21-61SP & 21-62SE – Ranch Road Staff Report

Address:	2600 Rustic Road & 1700 Ranch Road
Requests:	SP: Development of 303 multifamily units and amenity center SE: Relief from Sec. 122-434(1)(b) to reduce the required number of parking spaces to 1.6 spaces per unit
Owner:	AG EHC (MTH) Multi State 1, LLC
Applicant:	South City Partners
Agent:	Bill Conerly, P.E. – Kimley-Horn and Associates
Parcel ID:	0362001007, 0362001015, & 0362001002
Parcel Size:	15.85 ± acres
Future Land Use:	Mixed Use Residential (MUR)
Zoning:	Planned Unit Development (PUD)
Comprehensive Plan Neighborhood:	Knights Trail
Application Date:	December 27, 2021
Associated Petition:	21-63CU

Site Plan Overview

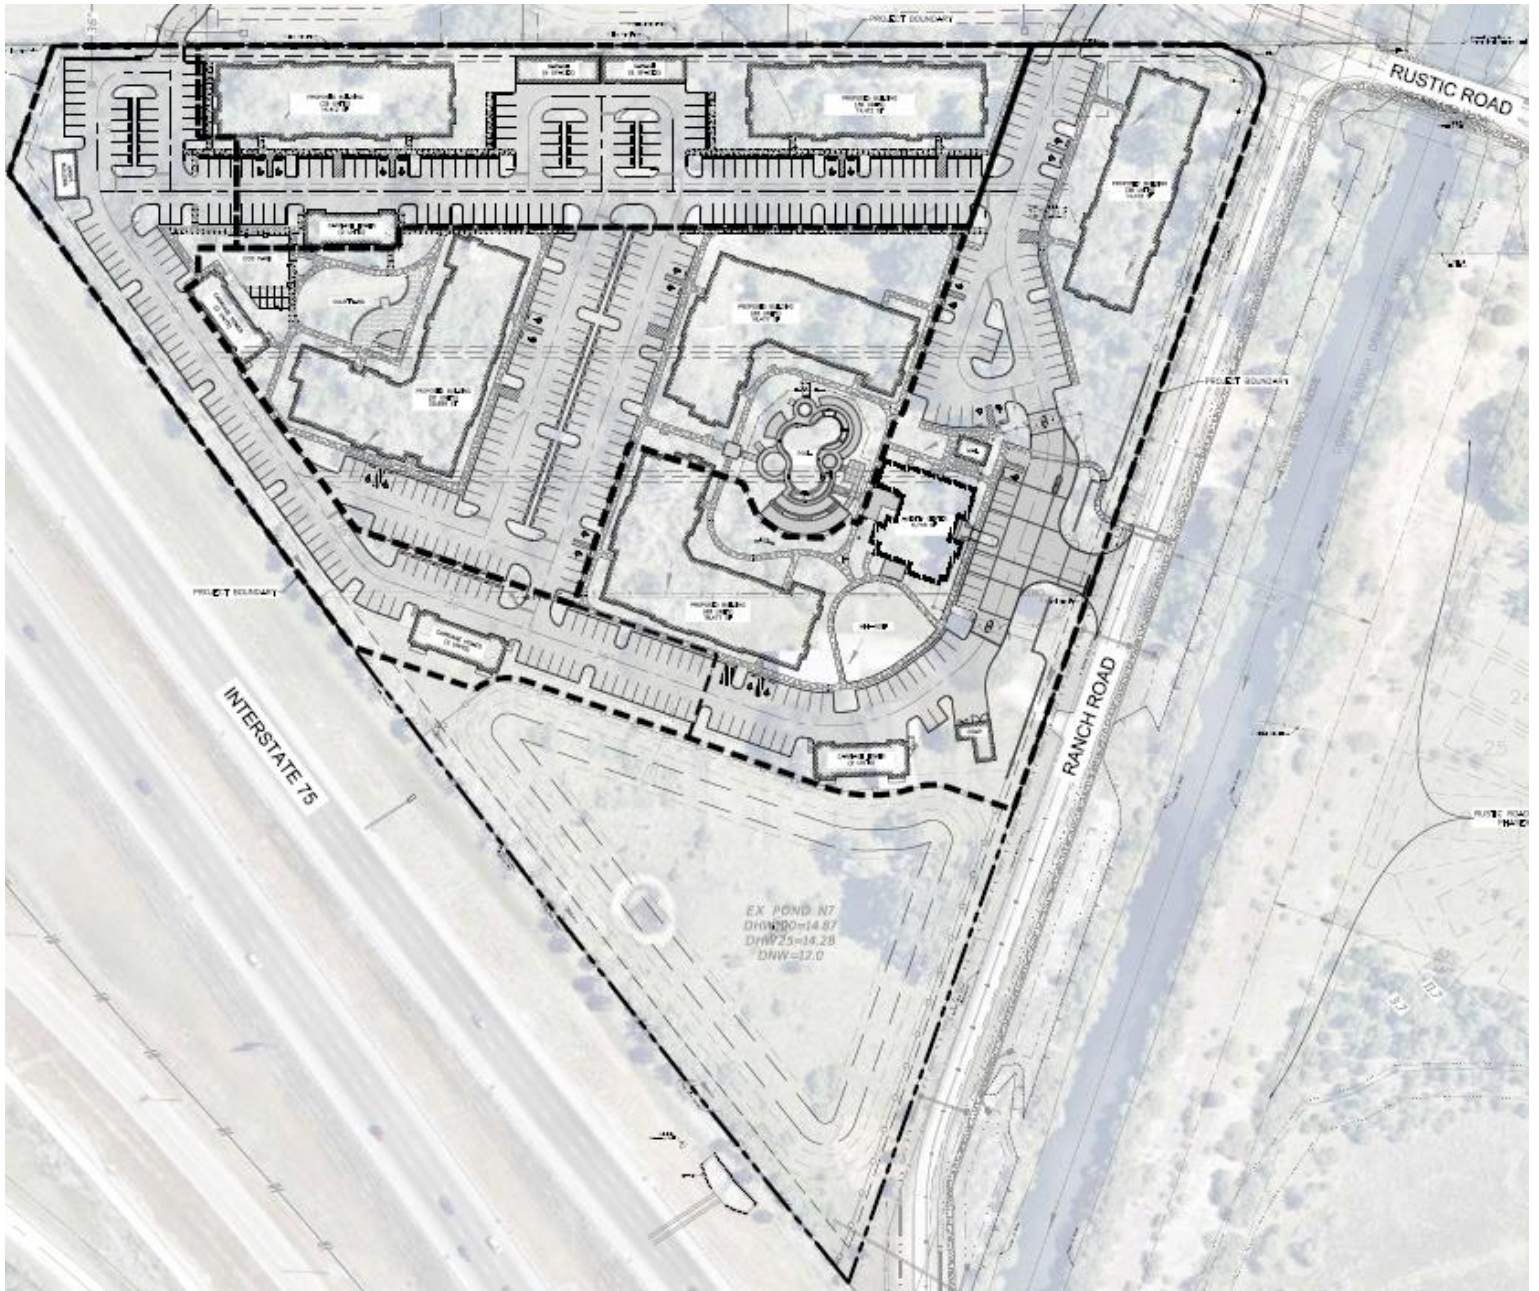
The subject parcel is triangular, bounded by I-75, Ranch Road (parallel to Cow Pen Slough), and Magnolia Bay North (single-family subdivision within the Rustic Road PUD). Landscape buffers 10' wide are provided around most of the property, with a 20' PUD perimeter buffer adjacent to I-75.

The proposed project is a 303-unit multifamily development with a mix of two-, three-, and four-story buildings, along with an amenity center and parking both on-street and in garages. Four of the ten residential buildings are identified as carriage homes, featuring two attached units. Three buildings contain 36 units, while the remaining buildings include one 51-unit and two 68-unit buildings.

The amenity center includes a pool, miniature golf, and a mail kiosk, and another open space area on the western side of the development provides a courtyard and dog park. A sidewalk is proposed throughout the development and connects to Ranch Road.

Staff Comment: Access is provided to the site at one main entrance along Ranch Road and two access points to the north, one from Rustic Road and one connecting to Magnolia Bay north. Sidewalks and crosswalks are provided throughout the site for pedestrian safety.

Staff Comment: Screening and buffering is proposed compliant with the Land Development Code and consistent with the Binding Master Plan, including increased buffering along the PUD perimeter adjacent to I-75.
